Access Compliance Report

Public Rights-of-Way

(Curb Ramps)

Intersection ID: 11717	Main Street: E_15TH_ST	Cross Street: N_DAVIDSON_ST	Location: S
ADA ID: 82C773CD550F	Ramp Type: PerpDiag	Initial Pass/Fail: Fail	Overall Compliance: No
			Severity Score: 21.25

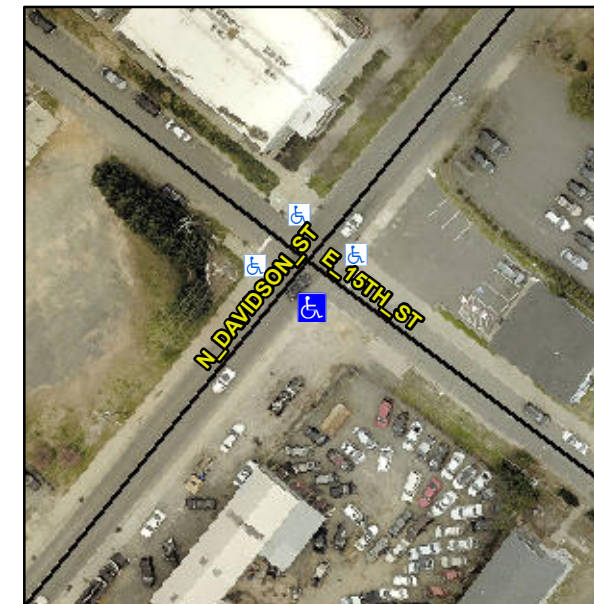
Not Found, R304.5.1, R304.2.2

Compliance	Description	Data	Compliance	Description	Data
N/A	Ramp Length (in)	37.0	No	Ramp Slope (%)	8.4
No	Ramp Width (in)	47.5	Yes	Ramp XSlope (%)	0.3
N/A	Flare Type LT	N/A	N/A	Flare Type RT	N/A
N/A	Flare Slope LT (%)	N/A	N/A	Flare Slope RT (%)	N/A
N/A	Flare Traversable LT?	N/A	N/A	Flare Traversable RT?	N/A
N/A	Landing Length (in)	N/A	N/A	DWS Provided?	N/A
N/A	Landing Width (in)	N/A	N/A	DWS Contrast?	N/A
N/A	Landing Slope (%)	N/A	N/A	DWS Length (in)	N/A
N/A	Landing X Slope (%)	N/A	N/A	DWS Full Width?	N/A
N/A	Landing Curb? (Y/N)	N/A	N/A	DWS Offset (in)	N/A
N/A	Shared Landing?	N/A			
N/A	Gutter Ponding?	Yes	N/A	Gutter Slope (%)	N/A
N/A	Gutter Lip Ht (in)	N/A	N/A	Gutter X Slope (%)	N/A
N/A	Painted X Walk1?	No	N/A	Painted X Walk2?	No
	X Walk 1 Direction	To NE		X Walk 2 Direction	To NW
N/A	X Walk 1 Width (in)	N/A	N/A	X Walk 2 Width (in)	N/A
	X Walk 1 Slope (%)	0.5		X Walk 2 Slope (%)	4.5
	X Walk 1 X Slope (%)	2.3		X Walk 2 X Slope (%)	1.9

Remove & Replace Curb Ramp With Two New Directional Ramps or Equivalent.
